UNITED STATES PATENT AND TRADEMARK OFFICE

APPLICATION NO.	FILING DATE	FIRST NAMED INVENTOR	ATTORNEY DOCKET NO.	CONFIRMATION NO.
10/553,405	11/10/2005	Dinand Lamberts	016782-0340	3705
22428	7590	01/04/2011	EXAMINER	
FOLEY AND LARDNER LLP			BERNSTEIN, DANIEL A	
SUITE 500				
3000 K STREET NW			ART UNIT	PAPER NUMBER
WASHINGTON, DC 20007			3748	
			MAIL DATE	DELIVERY MODE
			01/04/2011	PAPER

Office Action Summary	Application No.	Applicant(s)
	10/553,405	LAMBERTS ET AL.
	Examiner	Art Unit
	DANIEL A. BERNSTEIN	3748

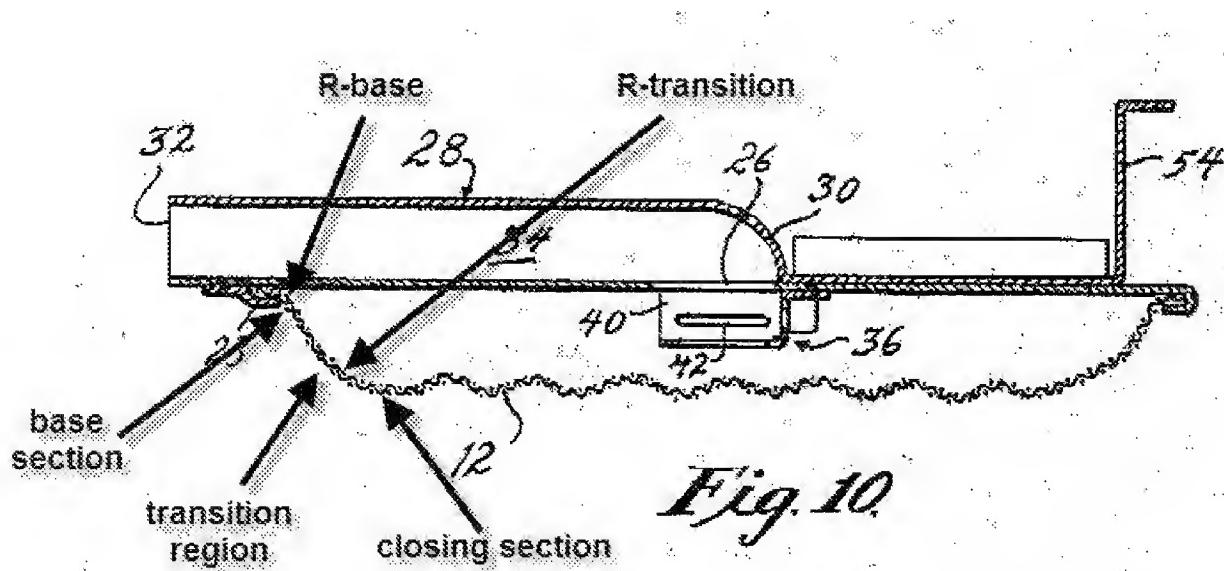
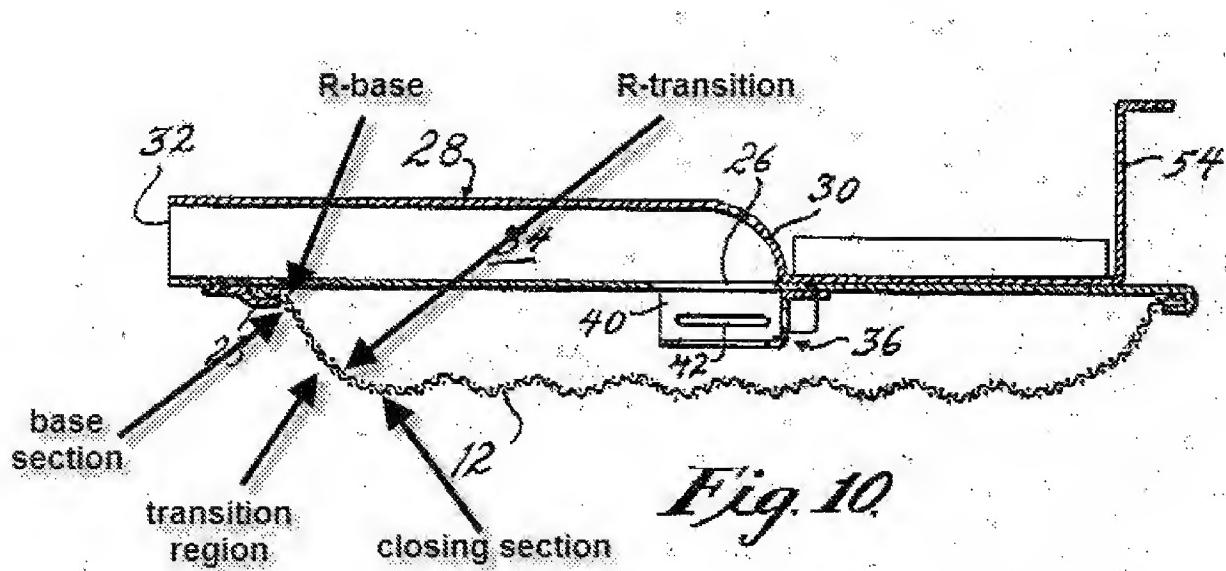
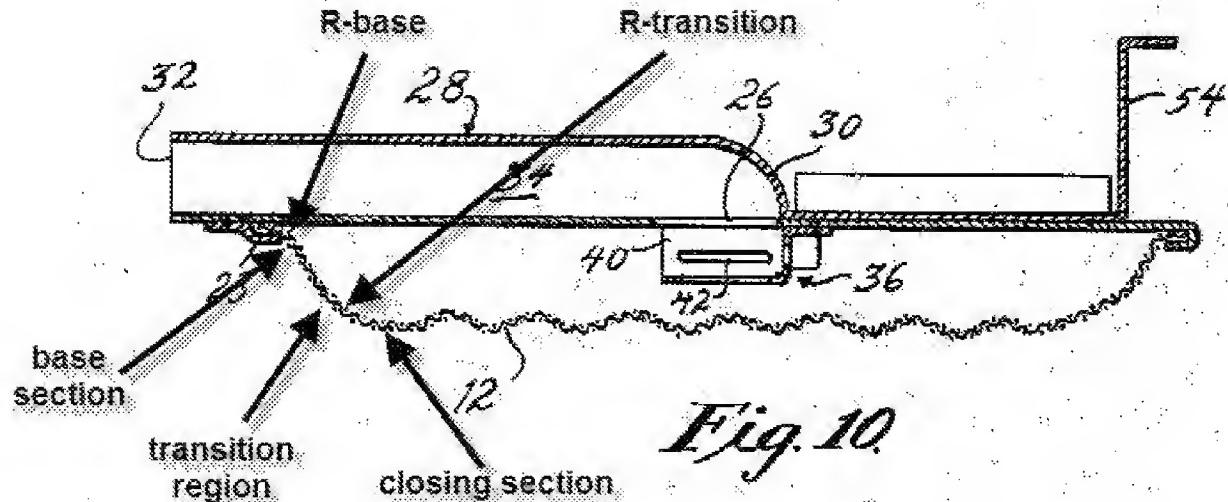
produced; and modulating gas speed through the membrane over the surface of the membrane (due to the nature of a steel or wire mesh, when the mesh is bent and shaped there will be regions where the holes in the mesh will become less or more restrictive to the flow of gas. This behavior of steel or wire mesh is inherent and very well known to someone of ordinary skill in the art. In this case, due to the shape of the transition region (being bent over) the speed of gas will be slower due to a more restrictive region than that of the base section where the holes in the mesh are less restrictive, see annotated Fig. 10) by changing a smallest radius of curvature at different sections of the membrane.

In regards to claim 32, Saponara shows that a first section (transition region, annotated Fig. 10) of the membrane has a first smallest radius (the transition region has the smallest radius of curvature which will result in a more concentrated restrictive mesh and therefore a lower flame front) of curvature that results in a first gas speed (lower

gas speed due to more restrictive flow) through the membrane, wherein a second section (closing section, annotated Fig. 10) of the membrane has a second smallest radius (the closing section has a larger radius of curvature than the transition region and therefore a higher gas speed due to less restrictive flow through the mesh) of curvature that results in a second gas speed through the membrane, and wherein the first gas speed is less than the second gas speed (the gas speed through the transition region will inherently be less than the gas speed through the closing section due to a more restrictive mesh density).

Saponara also discloses that said membrane of the gas burner comprises a base section (base section at 23, Fig. 10) having a smallest radius (the smallest radius of curvature occurs at the bend near 23. Also see R-base in annotated Fig. 10) of curvature being R-base, a closing section (closing section, annotated Fig. 10), and a transition region (transition region, annotated Fig. 10) connecting said base section to said closing section (the transition region connects the base section with closing section as shown in annotated Fig. 10), wherein said membrane is uninterrupted (the membrane 12 is continuous and uninterrupted), and wherein said transition region has a smallest radius of curvature rtransition (R-transition, annotated Fig. 10).

In regards to claim 16, Saponara in view of Marrecau discloses that said closing section is a small inverted sphere cap (see annotated Fig. 10 where the closing section has the shape of a small inverted sphere cap which forms a depression at a center of the membrane between the first and second undulation) such that a depression forms at a center of said burner membrane.

In regards to claim 18, Saponara in view of Marrecau discloses that said transition region is in a form of a circular ridge (see annotated Fig. 10 where the transition region has the shape of a circular ridge).

In regards to claim 26, Saponara in view of Marrecau discloses that the smallest radius of curvature R-base (R-base, see annotated Fig. 10) of the base section and the smallest radius of curvature R-transition (R-transition, see annotated Fig. 10) of the transition region are determined from a side of the membrane which faces the flames (the smallest radius of both the base and transition region can be determined from the top side of the membrane).

skill in the art. In this case, due to the shape of the transition region (being bent over) the speed of gas will be slower due to a more restrictive region than that of the base section where the holes in the mesh are less restrictive, see annotated Fig. 10). .

In regards to claim 31, Saponara discloses that the membrane of the gas burner comprises a base section (base section, annotated Fig. 10) having a smallest radius (smallest radius of curvature R-base, annotated Fig. 10) of curvature being Rbase, a closing section (closing section, annotated Fig. 10), and a transition region (the transition region connects the base section to the closing section as shown in annotated Fig. 10) connecting the base section to the closing section.
